SITE SURVEY
A PART OF THE SOUTHWEST FRACTIONAL 1/4 OF SECTION 30, T.3N., R.11E., CITY OF ROCHESTER HILLS, MICHIGAN, OAKLAND COUNTY, COMMONLY KNOWN AS: 3600 AUBURN RD., ROCHESTER HILLS, MI 48307; PARCEL ID#15-30-376-032

PROPOSED
RENOBATION AND ADDITION
3600 W. AUBURN ROAD
CASTLE COMMERCIAL CARPENTRY

**Subject: 3600 Auburn Road Development
3600 Auburn Road (Sidwell No. 15-30-376-032)
Site Plan Review #1
Site Plans dated March 25, 2025
ASTI File No. A25-1482.08**

SITE SURVEY

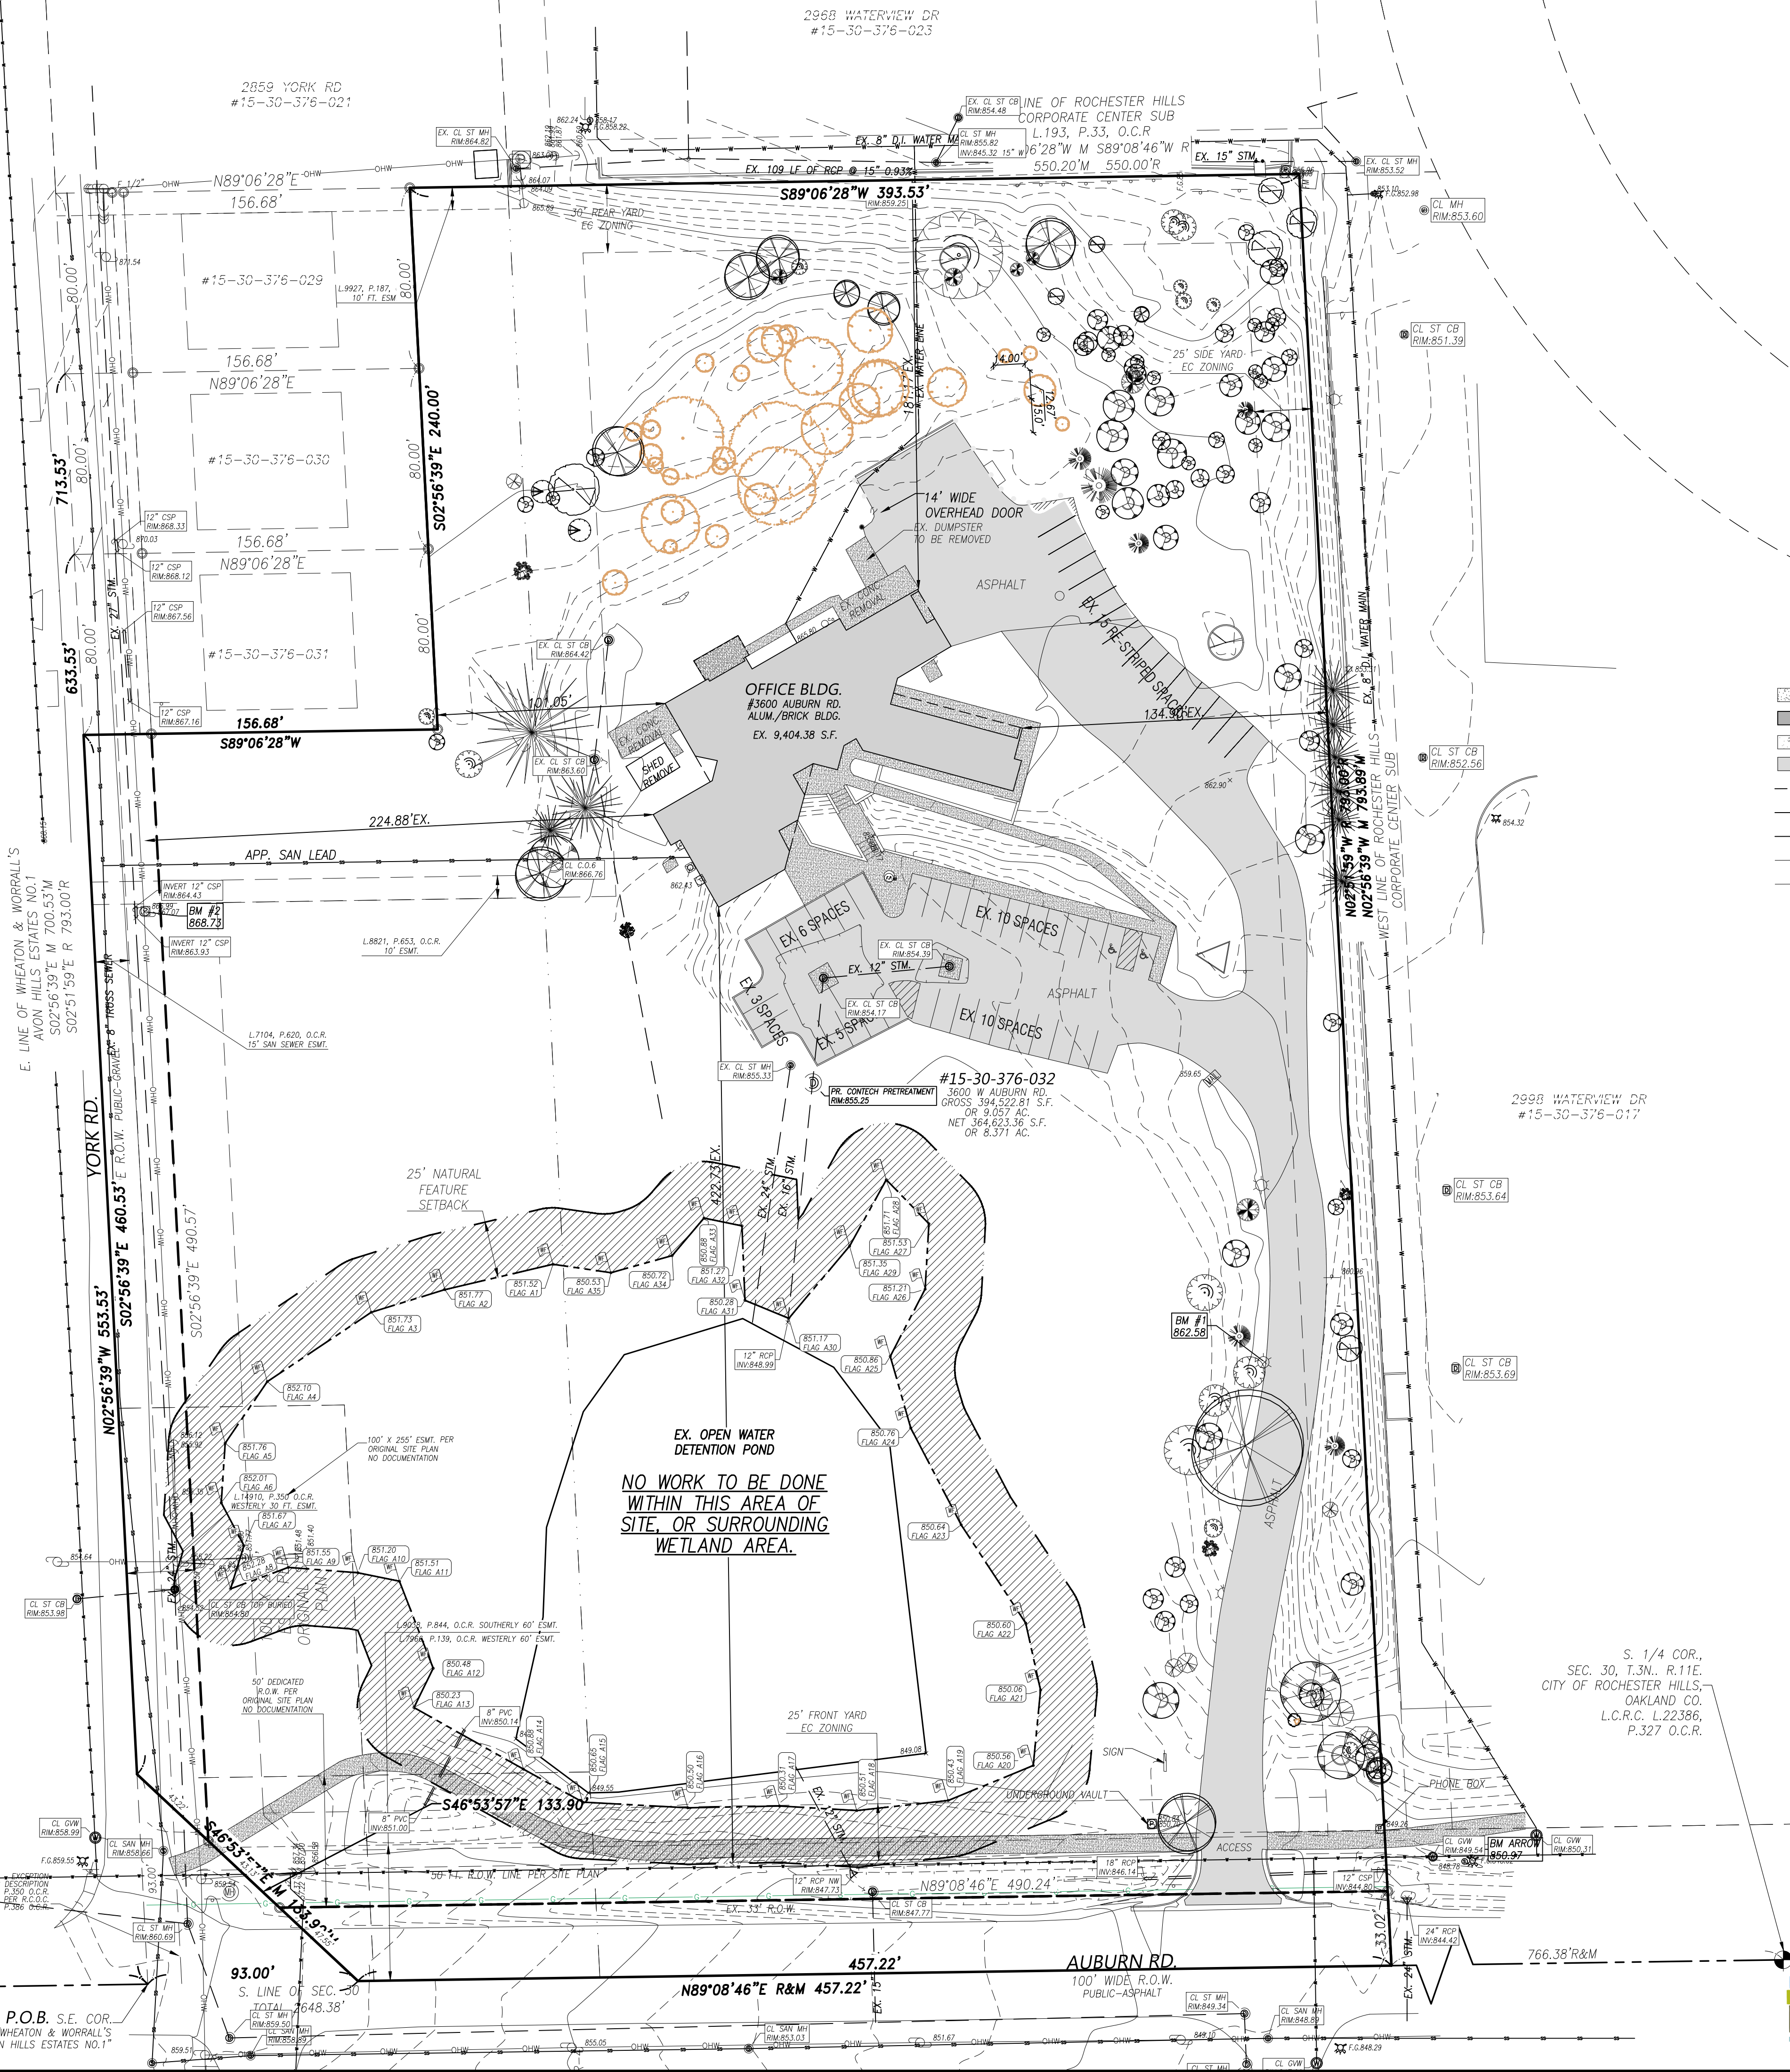
- a. This review has been undertaken in the context of a Wetland and Watercourse Boundary Determination completed on-site by ASTI on March 6, 2025. All flagging is shown on the Current Plans with alpha-numeric flagging as placed in the field by ASTI. *The Current Plans do not indicate that ASTI completed the delineation or what date it was completed; this must be shown on revised plans. Revised plans should also show the total wetland area including the open water portion of the wetland (1.5 acres) on all applicable sheets.*

ASTI recommends the City approve the Current Plans on the condition that the items in Comment 2.a are addressed on final plans.

LOWER LEVEL FLOOR PLAN

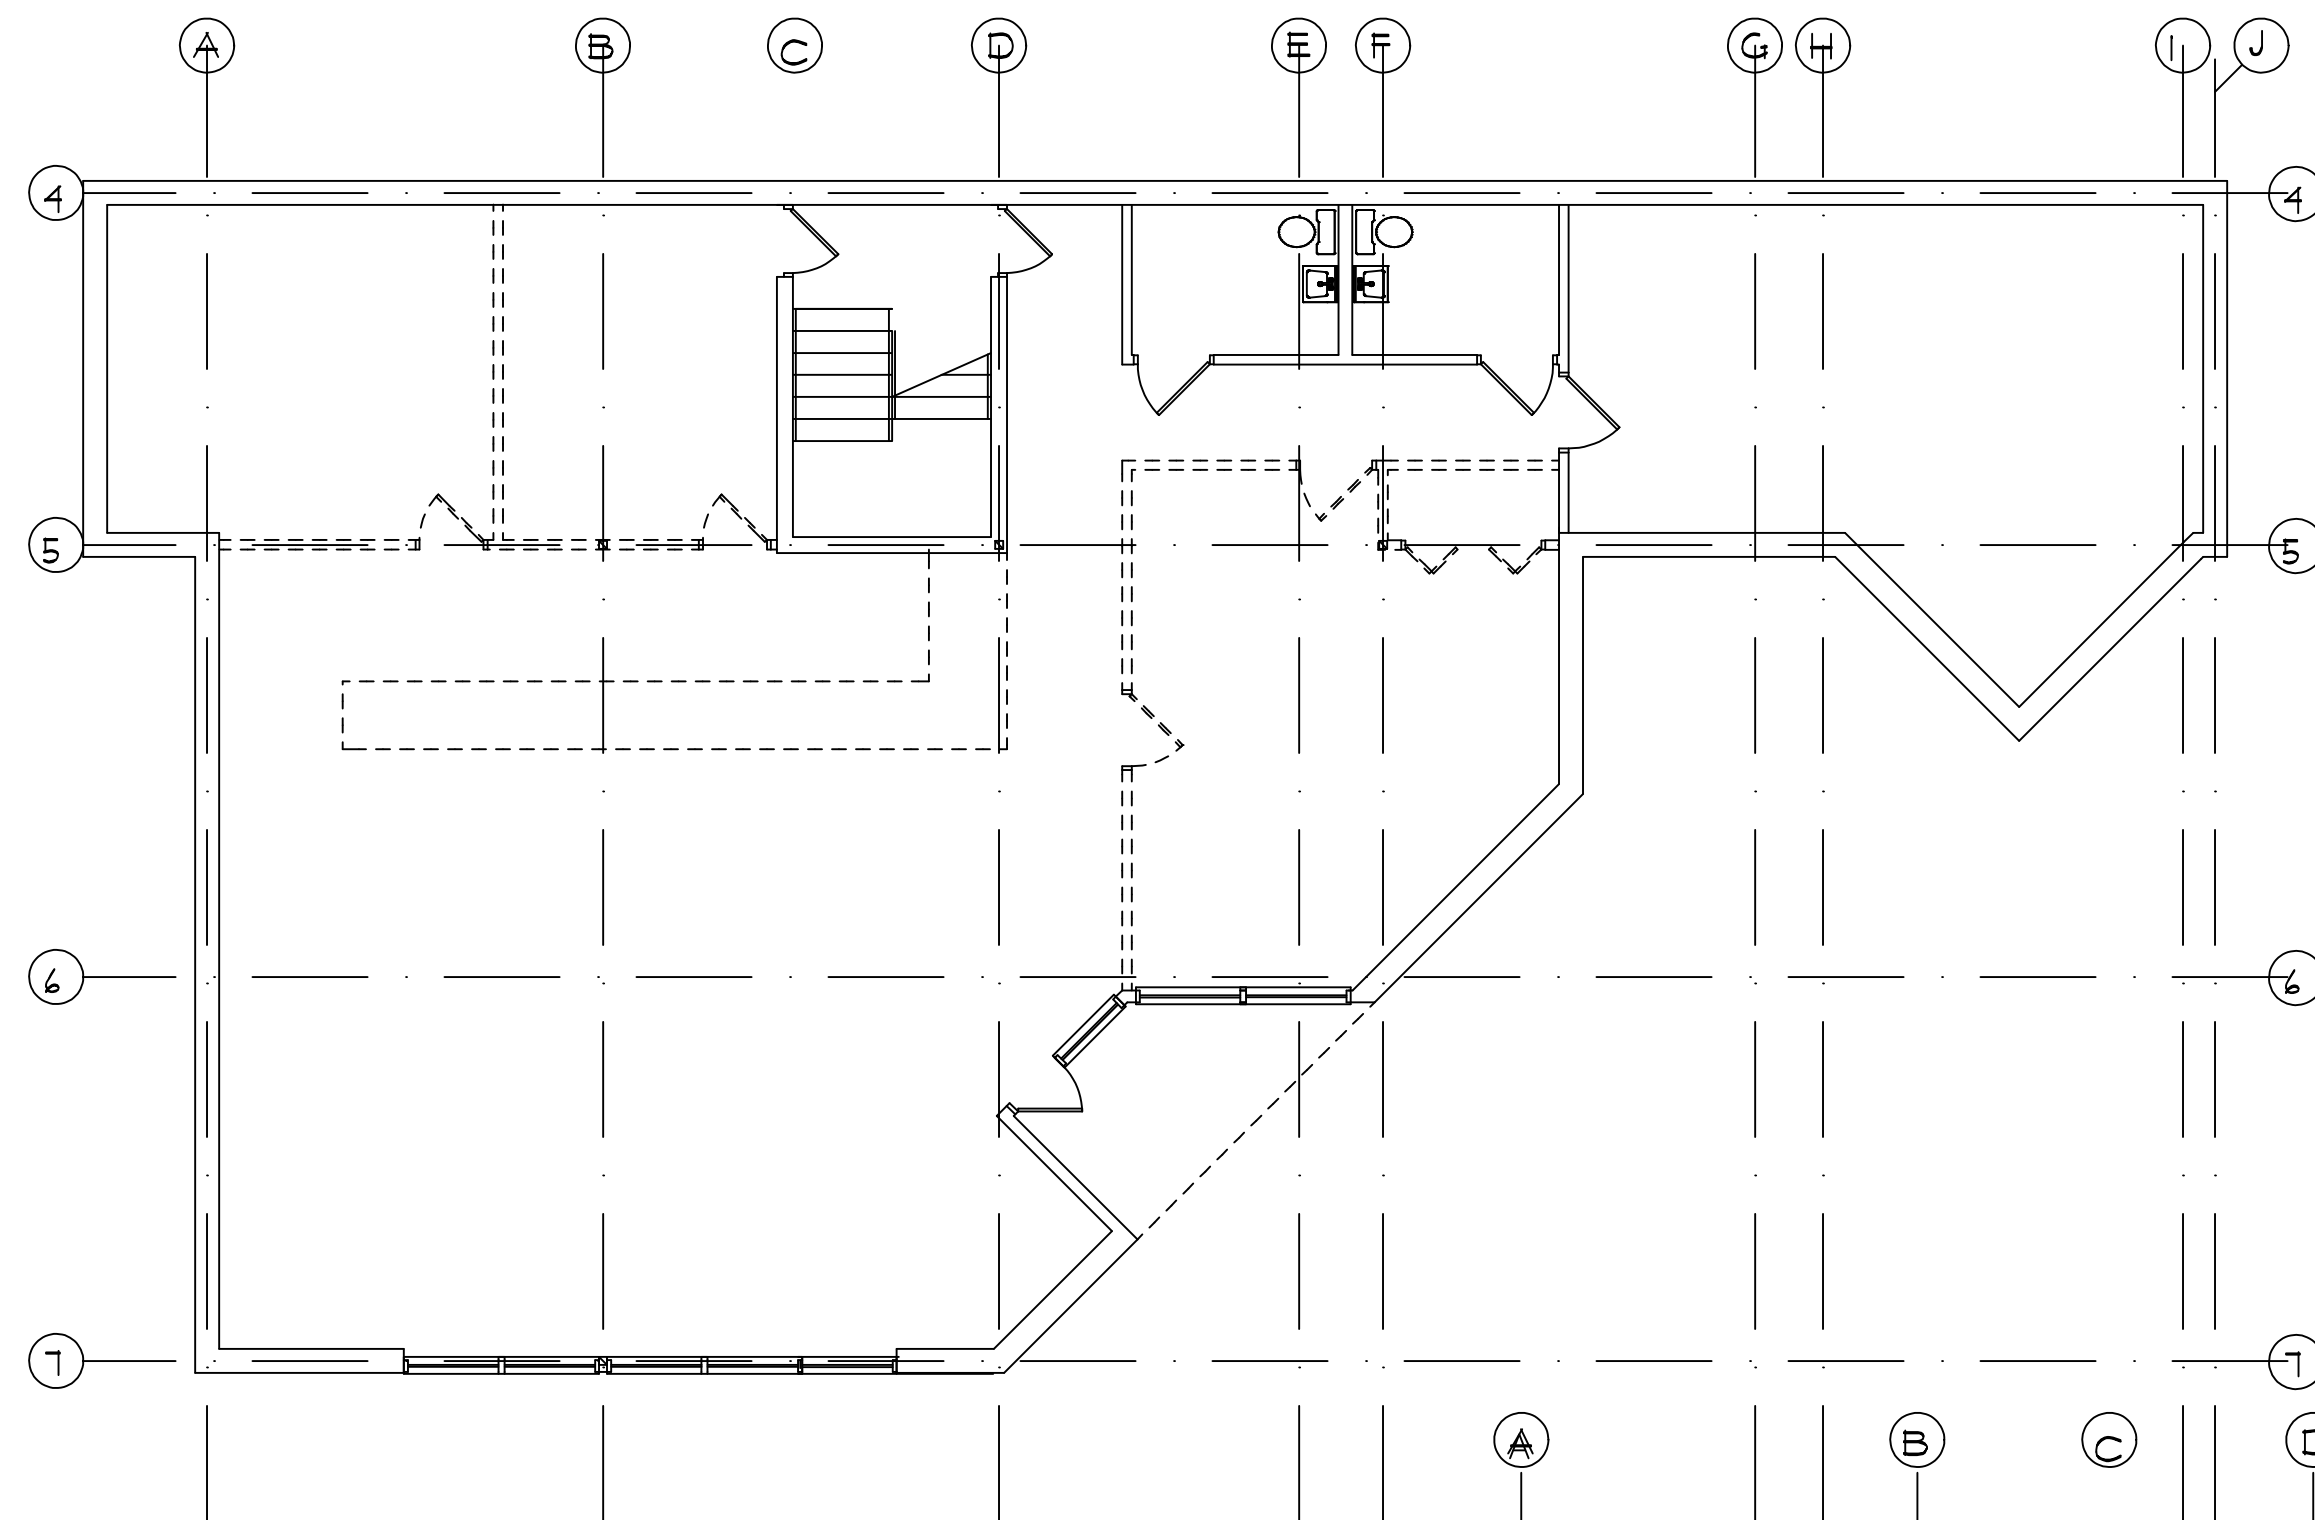
This project is being reviewed under the 2021 Michigan Building Code which goes into effect on April 9, 2025.

BUILDING FLOOR PLAN

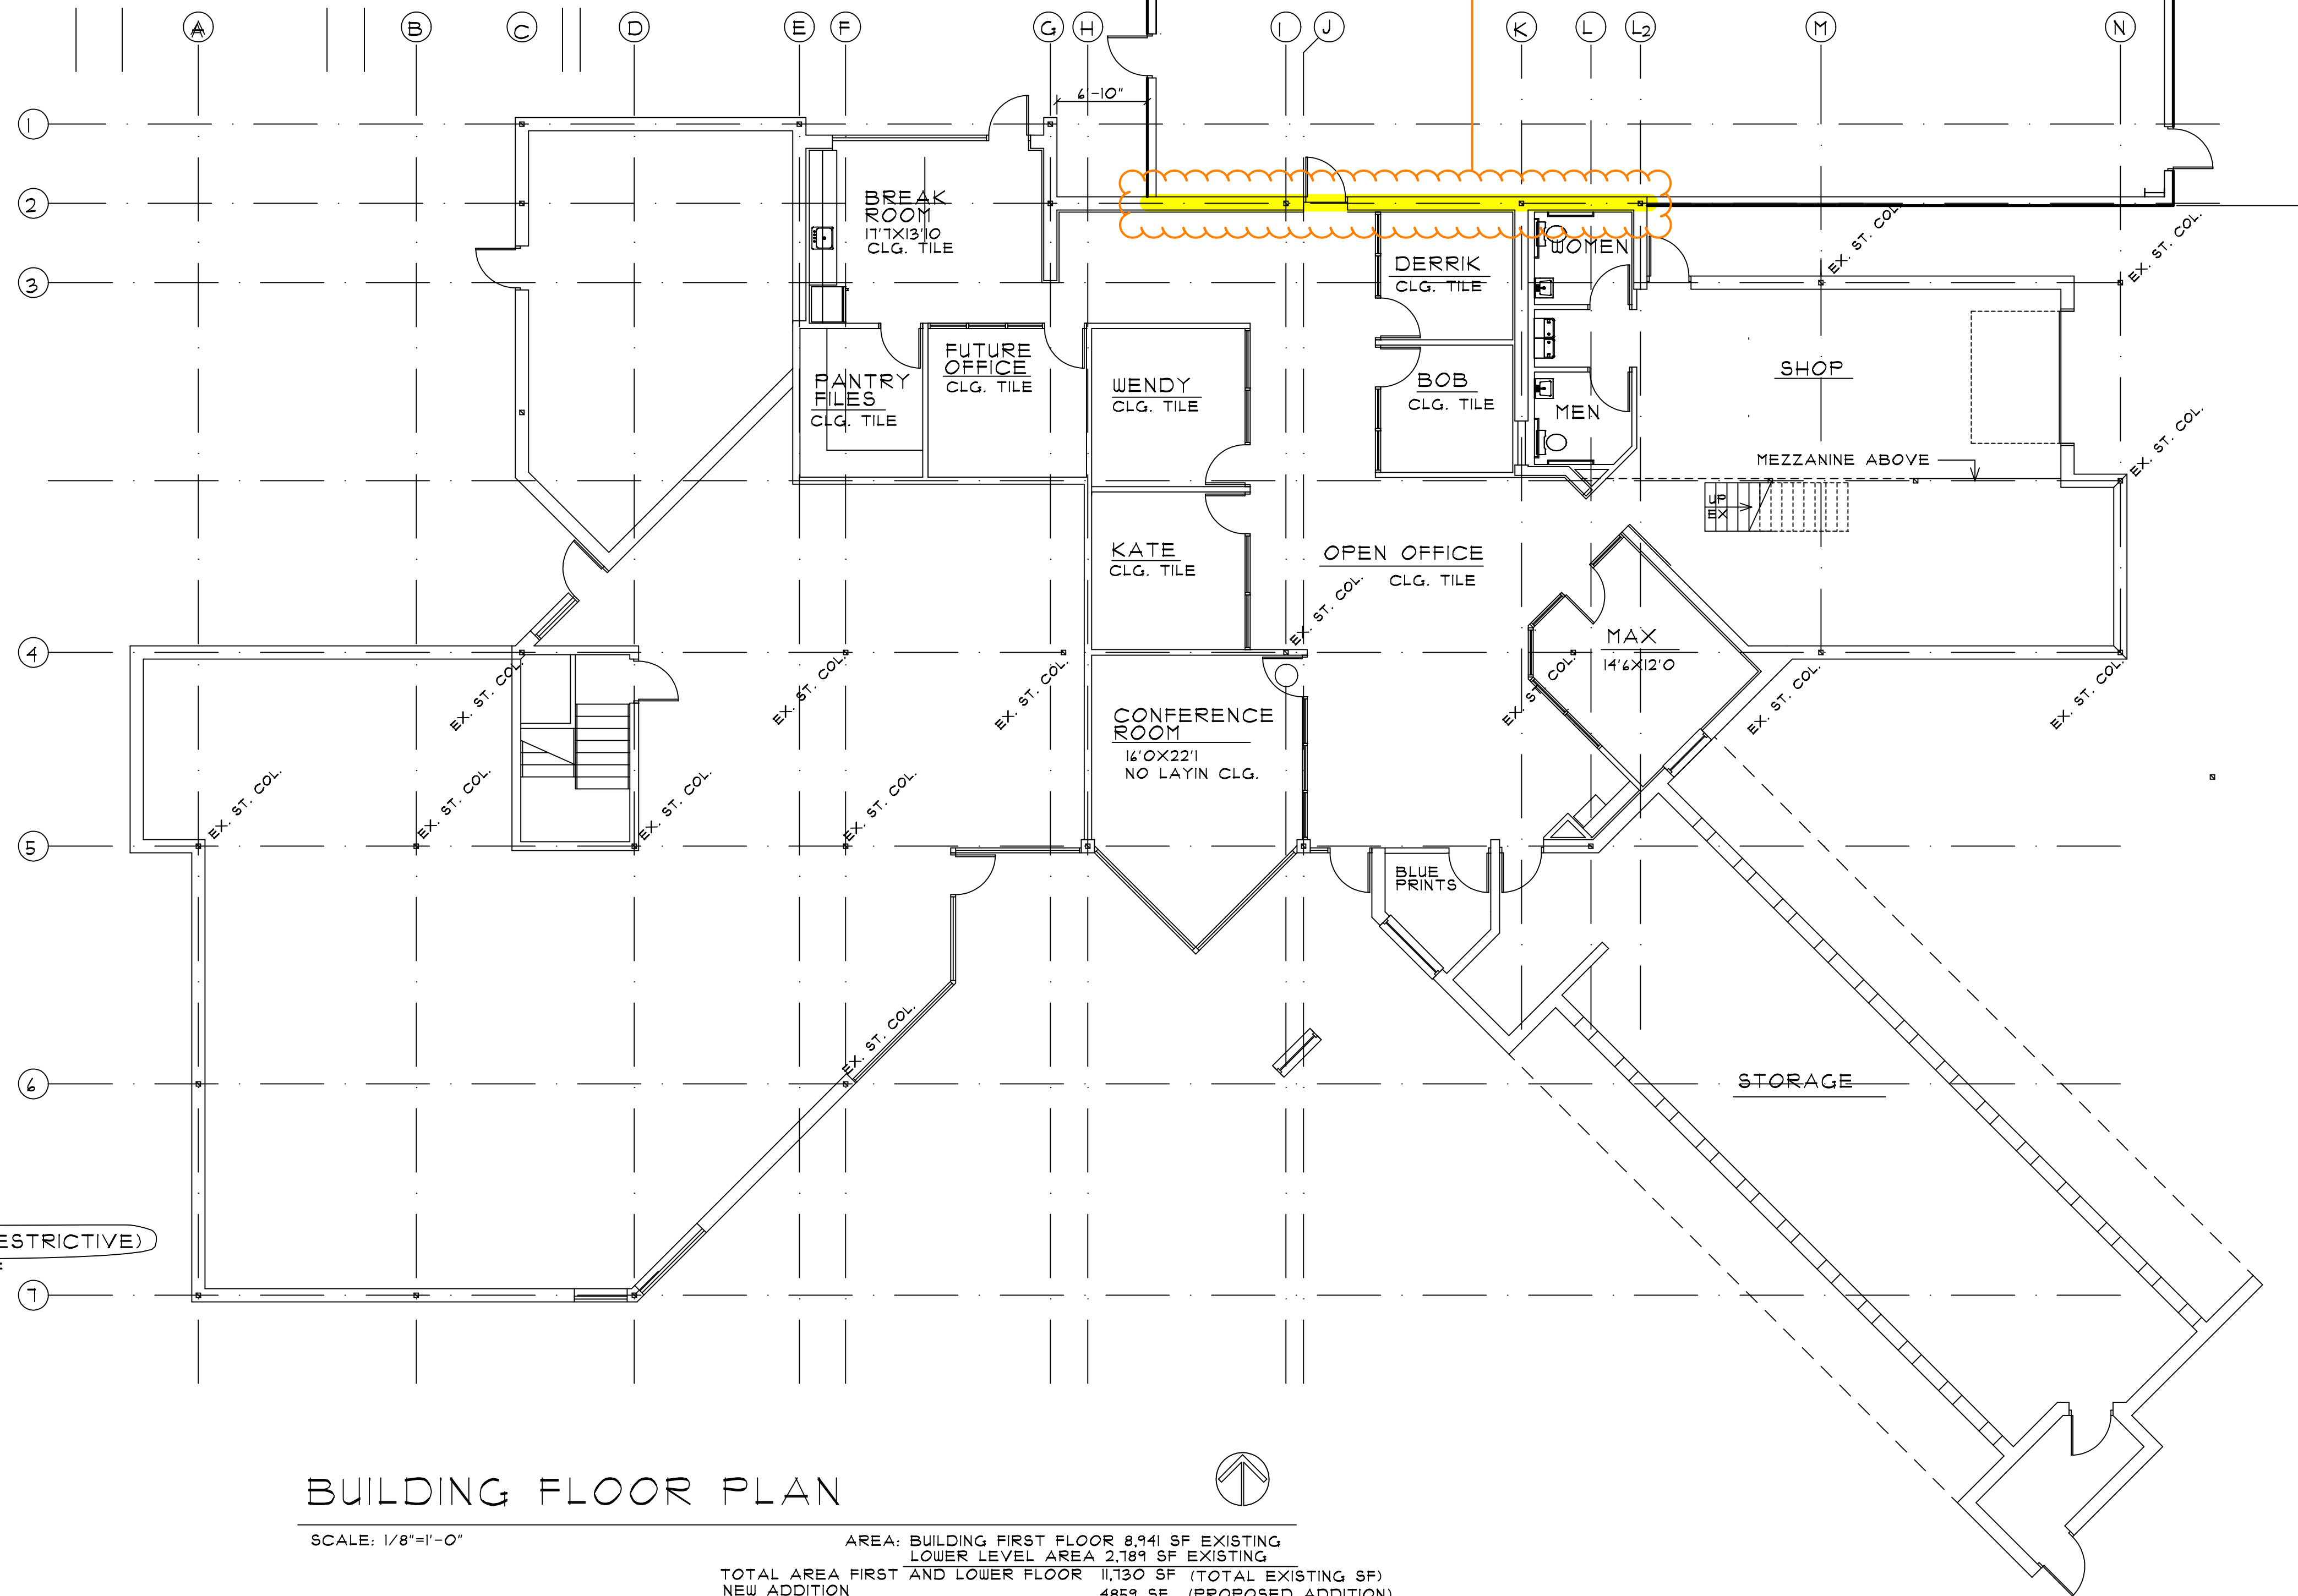
A 2 hour fire-resistant separation is required between occupancies per Section 508.3.1.
The fire area of the first floor of the building exceeds the allowable for a S-1 occupancy per Section 903.2.1, item #1, therefore the building shall be sprinklered or the mixed occupancies shall be separated.
If a fire-resistant separation is selected, Table 508.4 indicates no separation requirement between a B and S-1 occupancy. However, there is a 2 hour fire separation required between a B and a less hazardous S-2 occupancy. This Plans Examiner feels this is an inaccuracy in the building code that creates an unsafe conditions for the occupants and the more restrictive separation will be required.
